Subject: Bishop Tube Public Comment

**Comments on the Bishop Tube Site 8/17/2021
Analysis of Alternatives and Proposed Response**

I write to provide comments on the *Remedial Investigation Report* (RIR) and *Feasibility Study Report* (FSR) regarding the Former Bishop Tube Property, East Whiteland Township, Chester County, Pennsylvania, authored by Roux Associates, Inc. (2019a and 2019b). As you will read, I find that the analyses presented in the RIR are deficient in several respects; and I offer suggestions for improving upon these analyses. Because the FSR is based on the RIR, it too is unreliable.

Roux Associates (Roux) completed a Remedial Investigation Report (RIR) and Feasibility Study (FS) for the Bishop Tube (BT) site in 2021¹, which were updates to 2019 versions. The FS identifies potential remedial activities, as identified by Roux. A FS Addendum supplemented the FS report. In August 2021, the Pennsylvania Department of Environmental Protection (DEP) issued its Analysis of Alternatives and Proposed Response (AOA) in which it chooses its remediation plans for the BT site. The memorandum reviews that choice and DEP's reasoning.

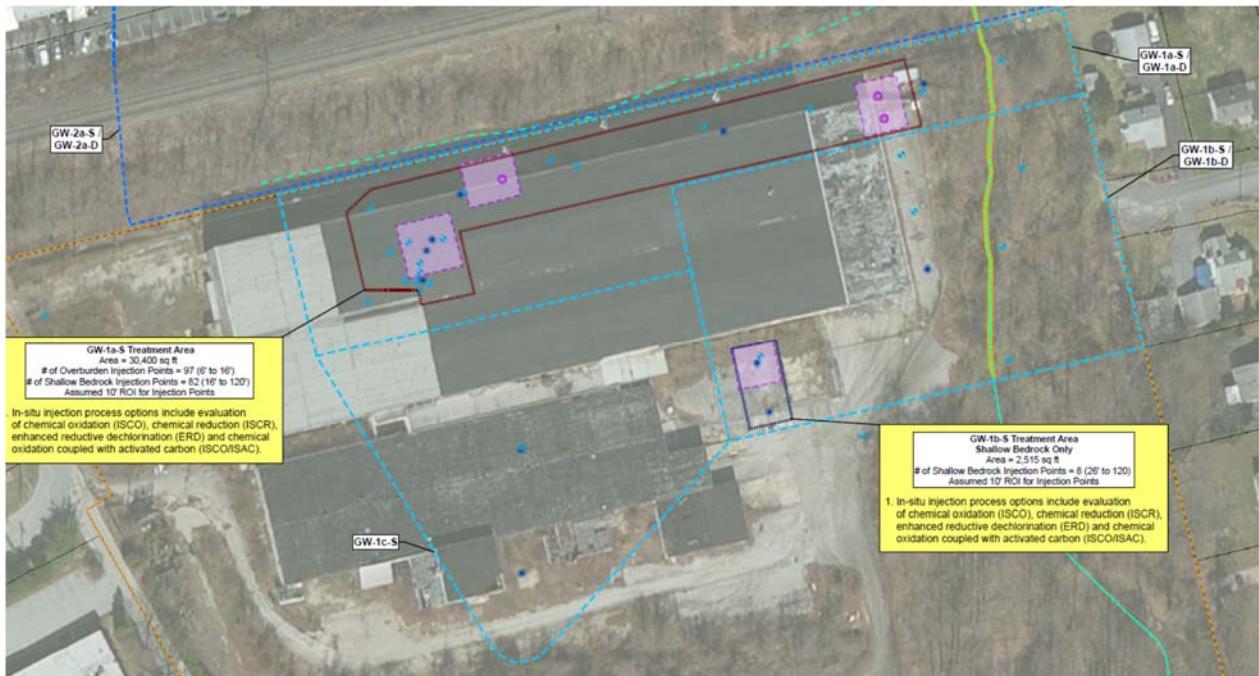
The injected chemicals are more viscous than water. Therefore, they will remain close to the injection point rather than moving quickly with groundwater flow. Especially in the shallow

bedrock, the injection solutions would flow through the more pervious fractures. Because the solutions would probably be heavier than water, they would sink deeper into the fractures rather than move as part of the groundwater flow. There would be a chance for the amendments to flow into lower permeability fractures, through diffusion and dispersion, just as groundwater otherwise moves into those fractures. Because of the high viscosity and being heavier than water, the treatments would be effective only near the point of injection. The FS does not analyze the radius over which it could be effective as it must do before DEP can select a density of injection locations. The FS also does not consider injecting chemicals directly into deep bedrock, even into obvious hot spots under or just northeast of the site. This is a failure that would allow a substantial amount of TCE go untreated and remain as a source in deep bedrock.

Figure 8: Snapshot of FS Figure 22 showing the conceptual design of best management practices to protect LVC.

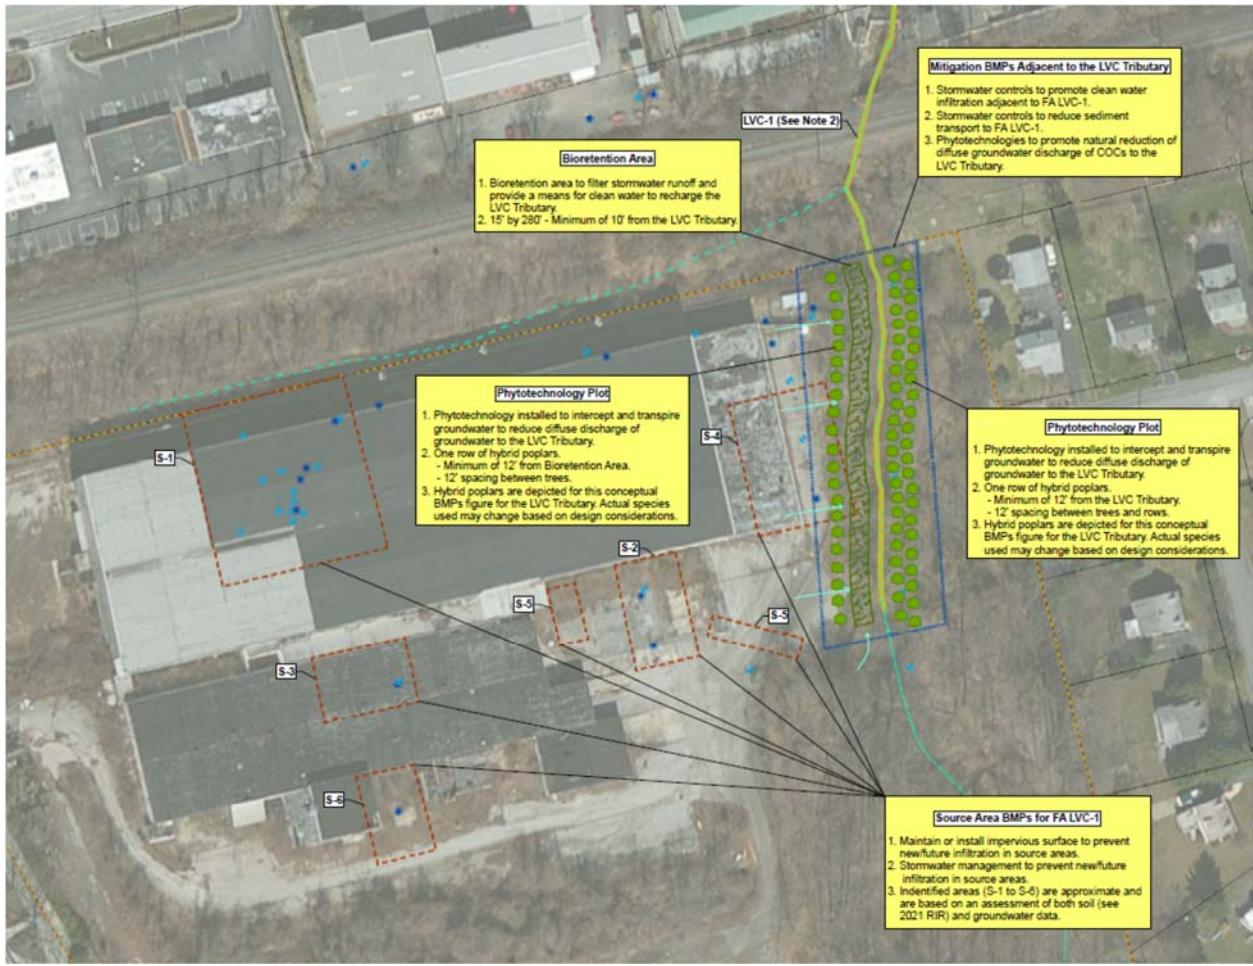
The first BMP proposed is that the six primary source regions, three for CVOCs and three for metals (Figure 8), be capped with an impervious layer. There is no consideration of how this would work with future development of the site. There is no consideration of the need for an impervious cap if the source within the soil is completely removed. There is also no consideration of a water balance barrier which would use most of the infiltration for plant growth and limit infiltration of CVOCs substantially.

Stormwater runoff will reach the LVC tributary if the site is developed. FS Appendix D suggests the use of bioretention areas adjacent to the west side of the LVC tributary to cause runoff to infiltrate. Bioretention areas would be a mixture of sand, soil and organic matter into which runoff would percolate. The runoff would then percolate into groundwater before reaching LVC. However, the bioretention area would only remove sediment, not dissolved CVOCs that could reach the creek. The RIR does not provide any samples of surface runoff, so there is no evidence regarding the quality of storm runoff from the current site.

The FS does not provide calculations as to the size of the bioretention area, but merely states it would need 4200 square feet (FS Appendix D, p 2). The FS failed to consider the volume of runoff that would have to be captured (dependent on the return interval of storm from which sheet flow runoff would be infiltrated) and calculate the needed size of bioretention area. The

Figure 9: Snapshot from FS Addendum Figure 1 showing the location of the two areas to receive active soils and groundwater treatment.

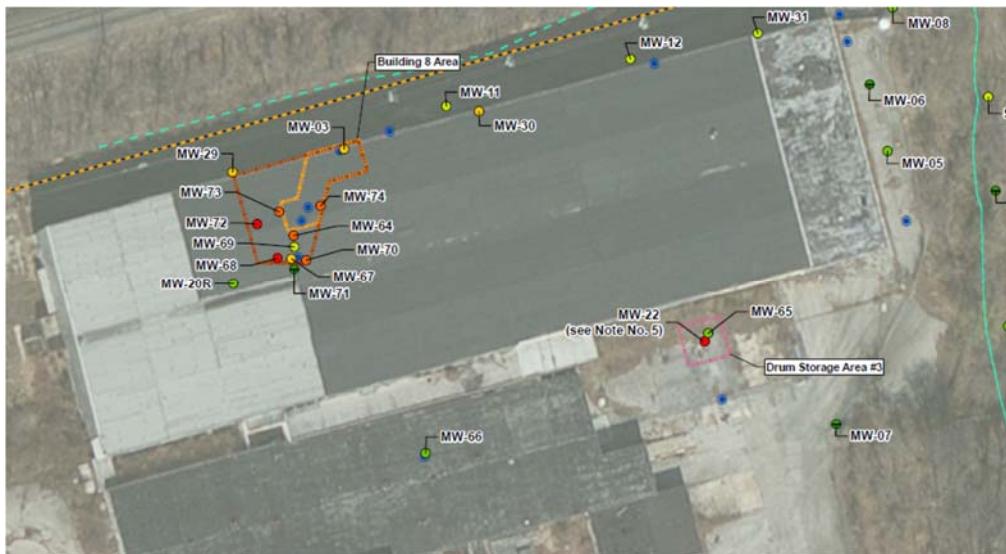
The soils remediation would involve using ISCR to treat in place the unsaturated soil at two locations (Figure 9), AOC 1 (Building 8 vapor degreaser area) and AOC 9 (Drum storage area near Building 5). The soil would also be mixed in place to enhance the placement of the ISCR amendments. Groundwater alternative 3 would be reduced to utilize ISCR at just two much smaller onsite locations (Figure 9) rather than the areas shown in Figures 3, 4 and 5. There would be no treatment of offsite areas north of the site.

This new alternative 8 leaves substantial TCE in the groundwater and is even less effective than other FS injection alternatives. This alternative leaves many areas, especially the high TCE concentration in the preferential flow zone offsite north of the northeast corner of the site.
